Potential For Engine Compartment Fires, Campaign 88-C-24

Number 88-C-24 Date June/90
PRODUCT SAFETY CAMPAIGN - 88-C-24
Subject: LACK OF ADEQUATE SERVICE OR MAINTENANCE
MODELS AFFECTED 1985-88 PONTIAC FIERO MODELS
WITH 2.8L V6 ENGINES (RPO L44)
TO: ALL PONTIAC DEALERS

ILLUSTRATION C - DECK LID

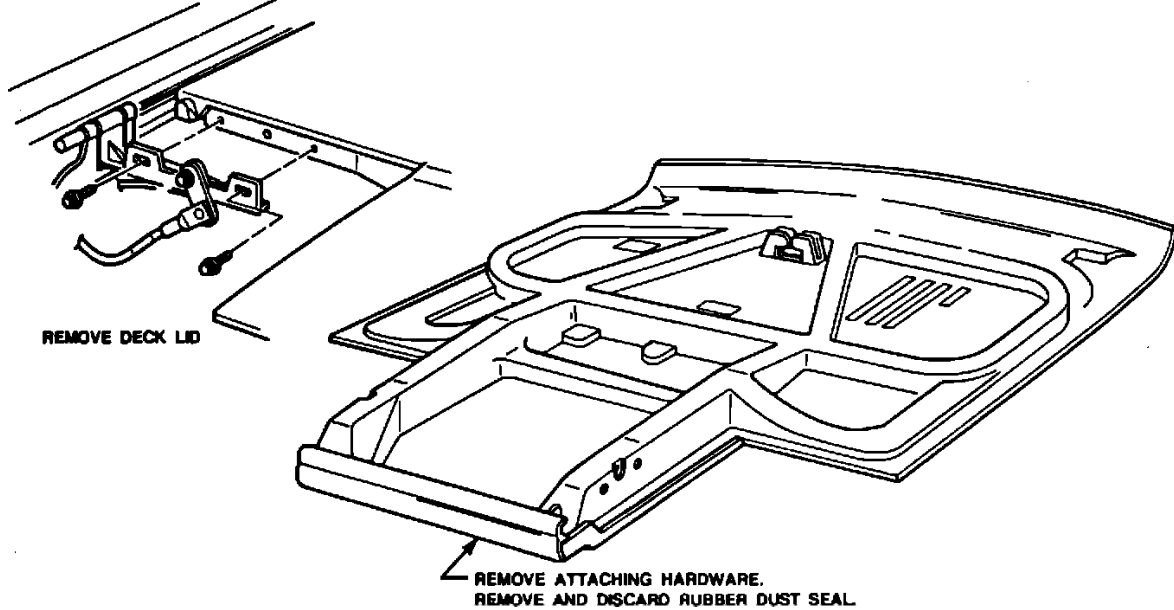
- b. Remove rear engine compartment lid. Remove rubber dust seal and retaining clips from leading edge (front) of decklid assembly (and leave off) (ILLUSTRATION C).

ILLUSTRATION D - AIR INTAKE DUCT SYSTEM 1985-86

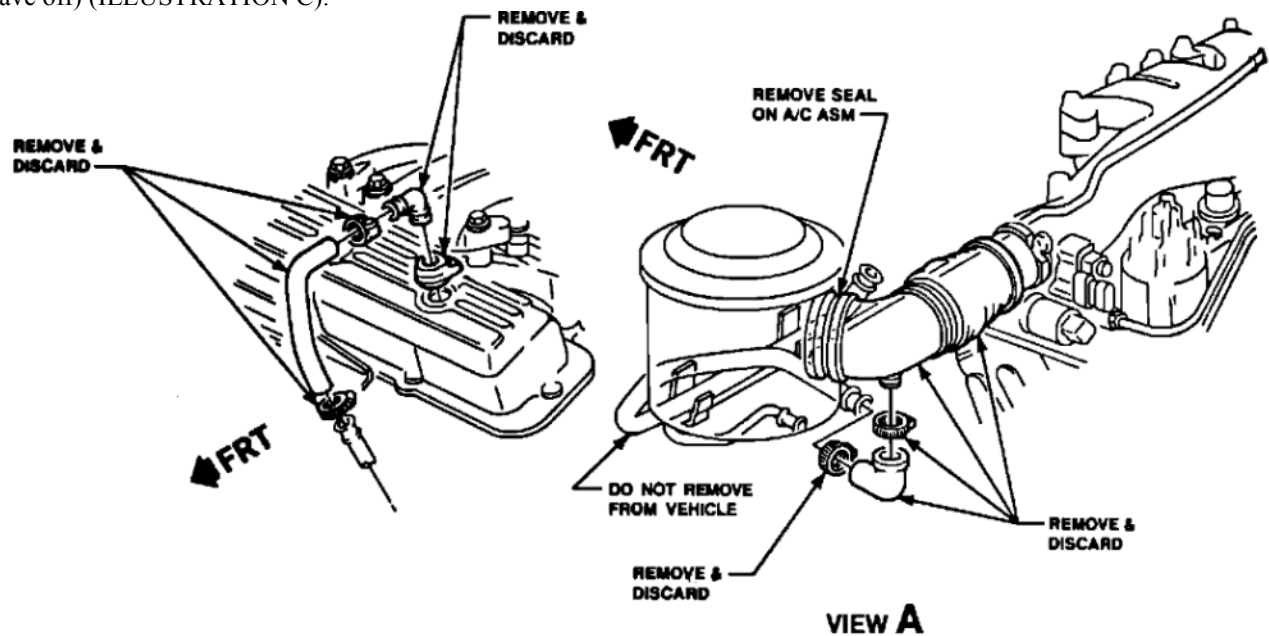
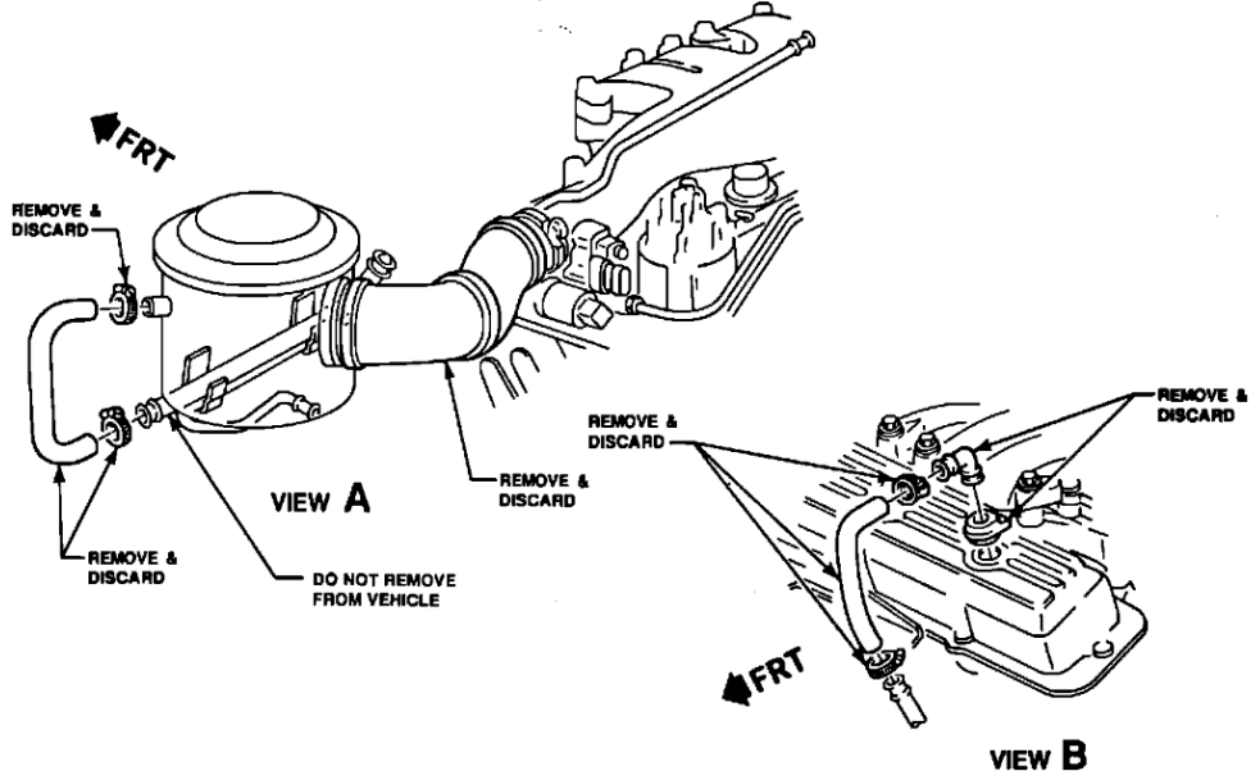
c. Remove air intake duct assembly (ILLUSTRATION D & E). Remove foam rubber seal on air cleaner housing neck (85-86 only). Remove PCV vent tube elbow(s), clamps and hoses at engine and air cleaner. **DO NOT** remove PCV vent tube mounted on forward engine compartment wall.

ILLUSTRATION F - MANIFOLD HEAT SHIELD

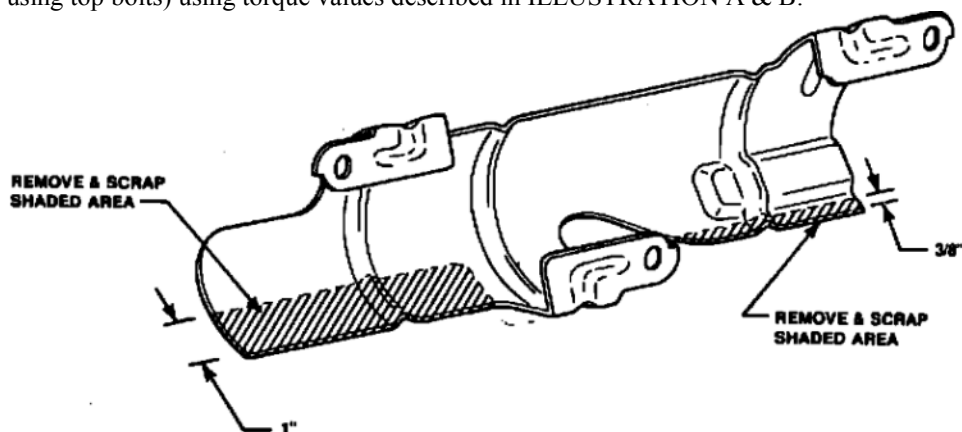
Modify (ILLUSTRATION F) and install outer manifold heat shield (dimensions for modification on illustration). Reattach cradle and torque cradle bolts according to the applicable Fiero Service Manual procedure. Remove jack stands. Lower vehicle.

ILLUSTRATION G - HEAT SHIELD ARTWORK

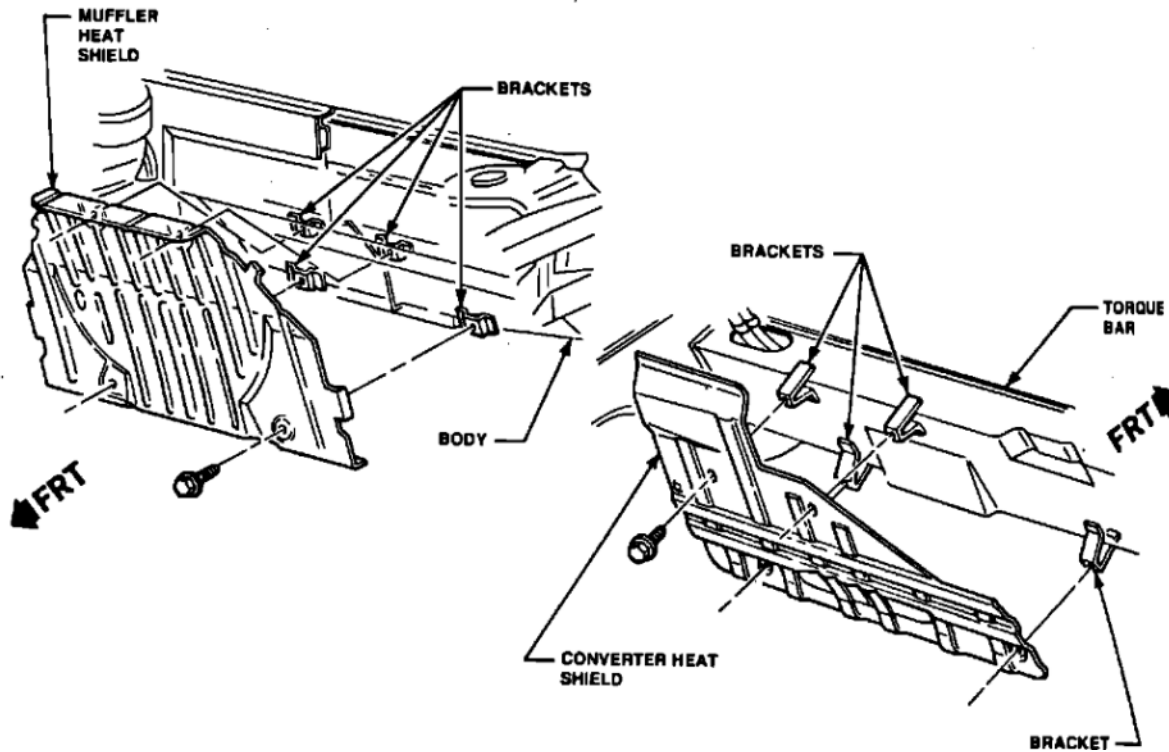
Any missing heat shield for this application (ILLUSTRATION G).

ILLUSTRATION H - PLUG WIRE CLIP

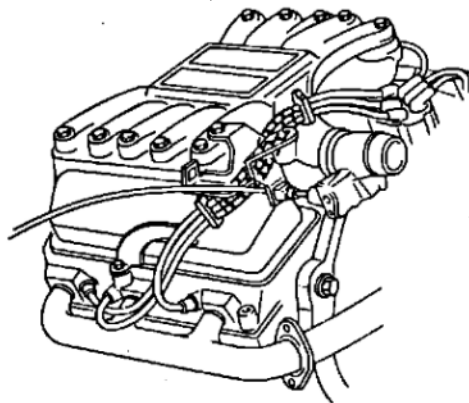
- bb. Lower vehicle. Remove plug wire clip, slide conduit up, and re-install clip, connect wires to spark plugs (ILLUSTRATION H). The clip is no longer seated on the bracket and should be repositioned above the edge of the rocker cover. Bracket should be removed.
- cc. Loosen shift cable bracket bolt (already installed on manual transmission equipped vehicles; bolt supplied in kit for automatic transmission equipped vehicles).

ILLUSTRATION I - AIR INLET (85-86)

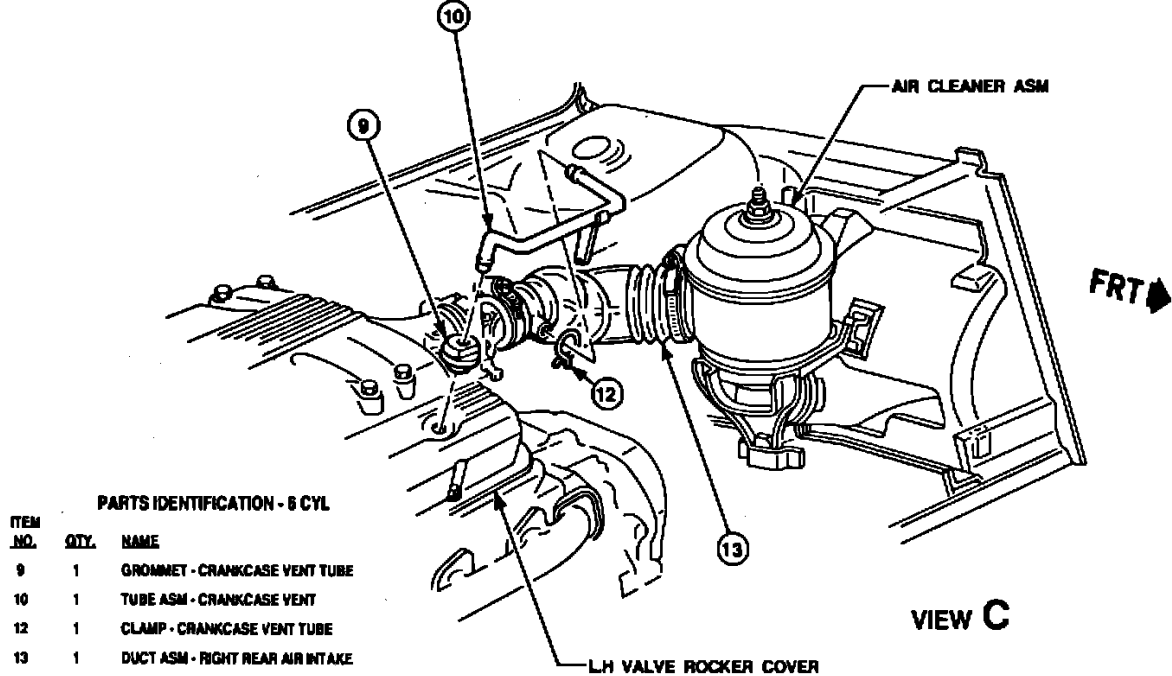
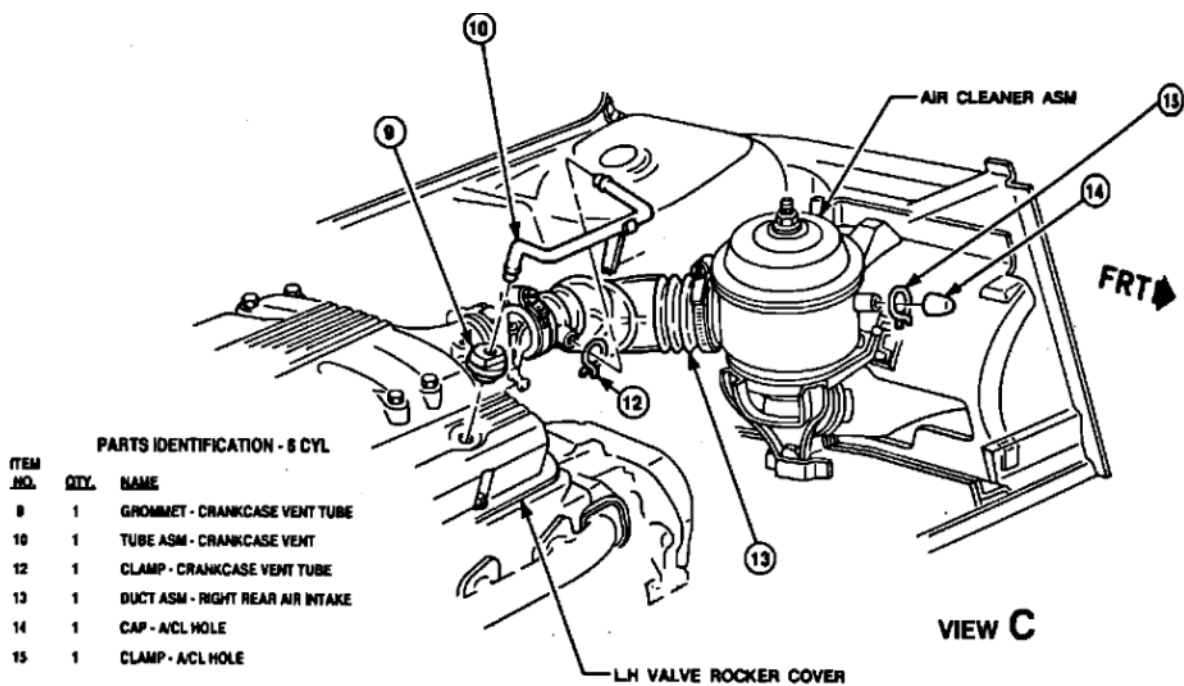
dd. Install new PCV grommet in the forward rocker cover, new air intake duct (w/clamps) and vent tube/bracket assembly. Orient grommet with flat side facing forward (ILLUSTRATION I & J). Position tube/bracket assembly under shift cable bracket bolt (manual transmissions) or install bolt supplied in kit (automatic transmissions). For 1987-88

vehicles, install rubber cap with clamp on air cleaner housing.
 Connect engine strut and torque according to the applicable Fiero Service Manual procedure.
